CITY OF FRANKLIN
COMMON COUNCIL MEETING
FRANKLIN CITY HALL – COMMON COUNCIL CHAMBERS
9229 WEST LOOMIS ROAD, FRANKLIN, WISCONSIN
AGENDA*
TUESDAY, MAY 16, 2017 AT 6:30 P.M.

REPORT TO THE PLAN COMMISSION

Project Name:	Interstate Partners Special Use and CSM
Project Address:	O West Oakwood Road (Tax Key No. 951-9994-001)
Applicant:	Caroline Brzezinski, Interstate Partners
Property Owner(s):	JAMS-4 LLC
Current Zoning:	Planned Development District No. 39
2025 Future Land Use:	Business Park
Use of Surrounding Properties:	Single-family residential and Wheaton Franciscan/Ascension Hospital to the north; trucking, areas of natural resource features, and single-family residential to the south; single-family residential and the City of Oak Creek to the east; and agricultural lands to the west
Applicant Action Requested:	Approval of the CSM and Special Use for two light industrial/light manufacturing mixed-use buildings

PLAN COMMISSION DRAWINGS FOR: INTERSTATE PARTNERS SPECULATIVE INDUSTRIAL BUILDING

L1.1

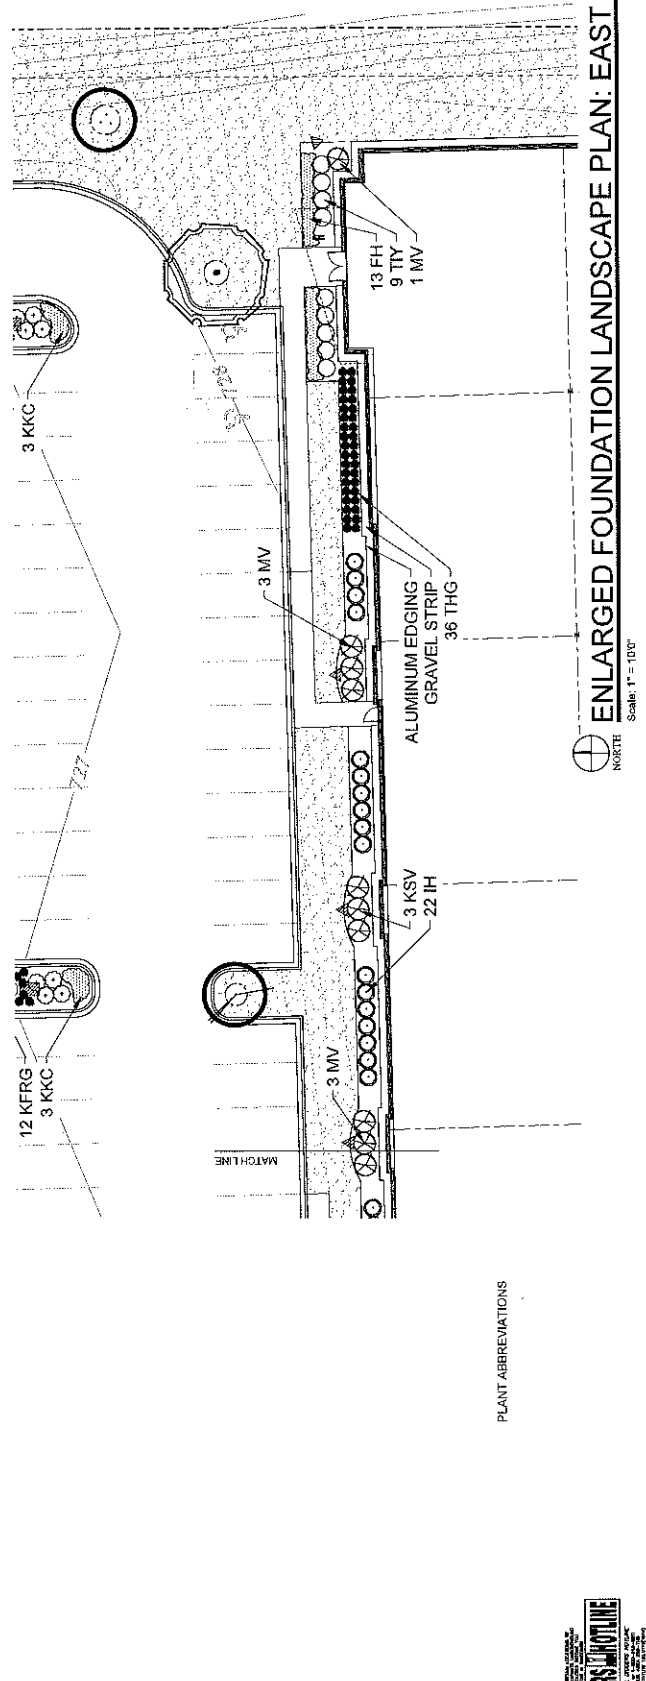
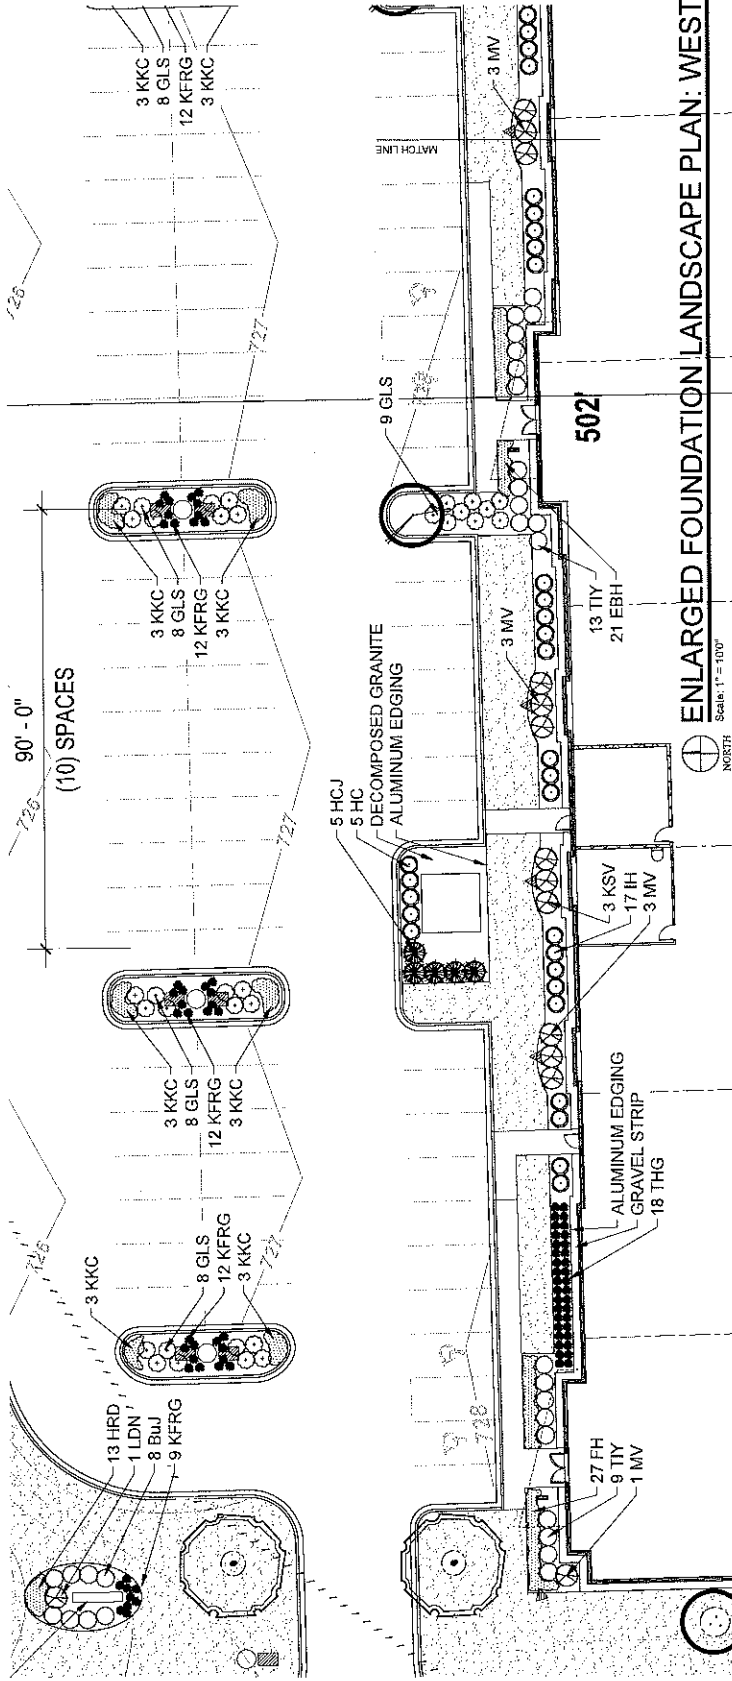
33. The table on Sheet L1.2 indicates 14 MV plantings. Sheet L1.1 illustrates 16 plantings. Please revise to be consistent. This has been corrected.
34. Staff recommends plantings within the parking lot islands. Note that staff does not object to mulch or stone being installed, opposed to grass. This has been addressed on the plans.

AS100

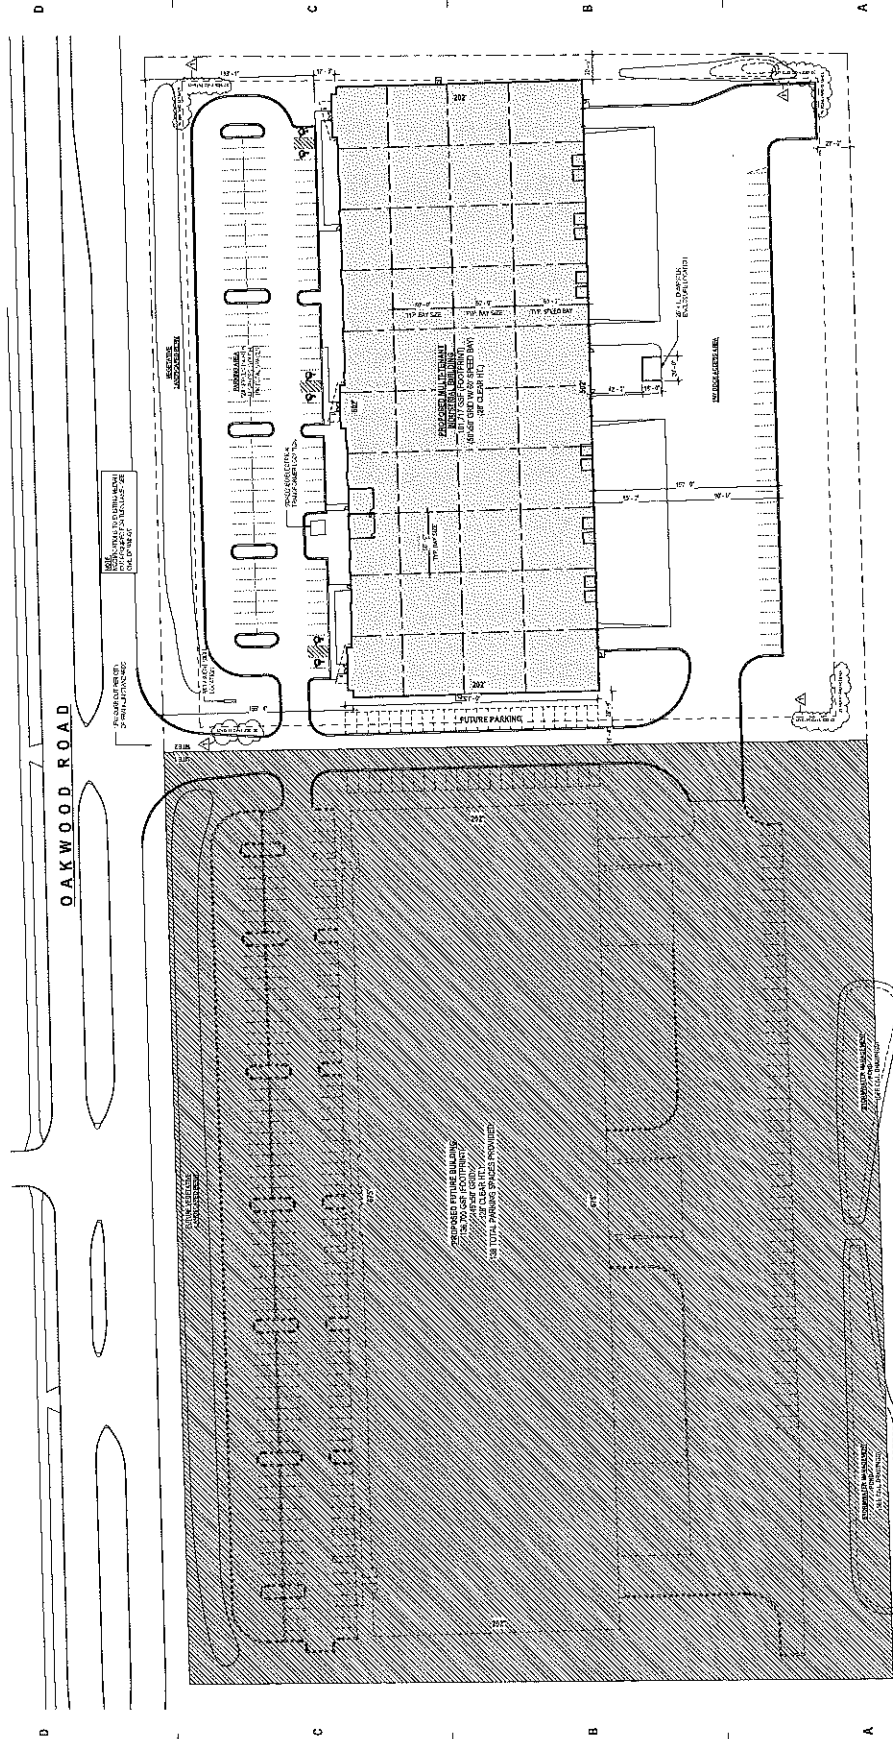
31. Sheet AS100 notes a 20' side yard setback. The side yard setback is 10'. Also, the rear yard setback is 25'. Please review setbacks and make sure they are correct and consistent throughout the plan set. Sheet AS100 shows actual distances, not required setbacks. All distances are in excess of setback requirements.

AS400

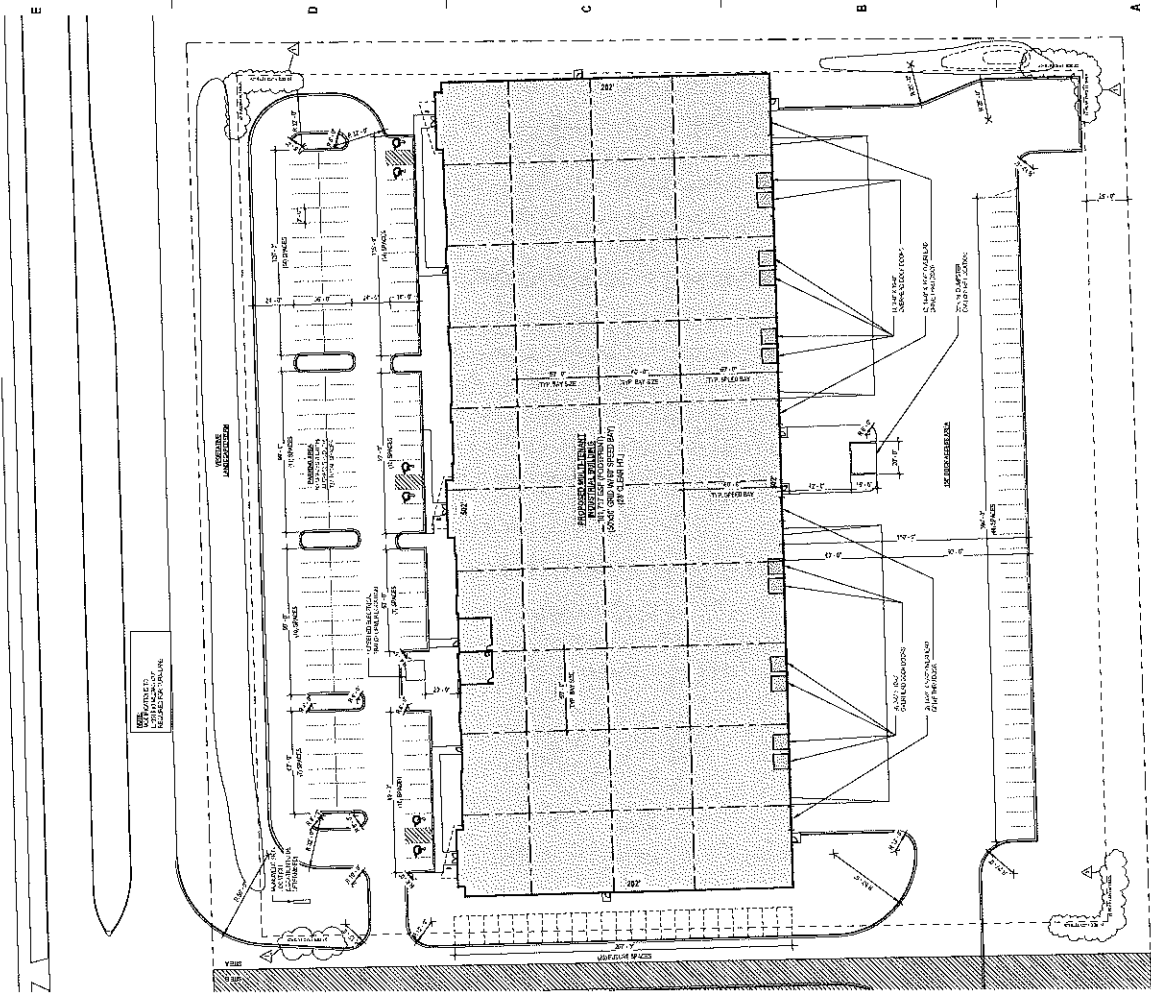
29. Sheet C110 parking summary is not consistent with Sheet AS400. Please revise (Sheet C110 is incorrect). This has been corrected.
30. Staff recommends amending item 16 on Sheet L1.2 to a two year planting guaranty as typically required by the UDO. A two-year guarantee is not available from the landscape contractor.

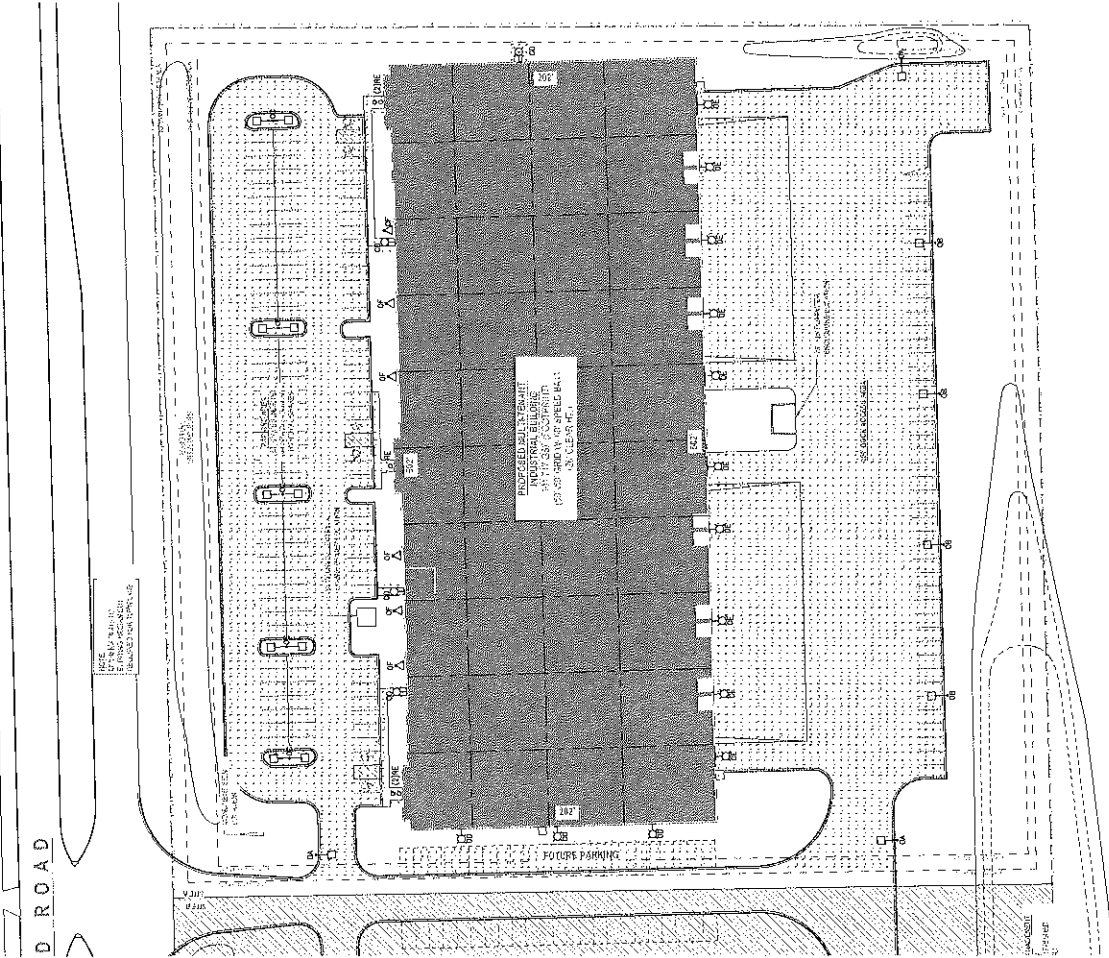
36. What is the height of the light poles and mounted height of the building light fixtures? Please note these heights on the Lighting Plan, Sheet ES100. The note does exist on the Lighting Plan. The height is 20 feet.
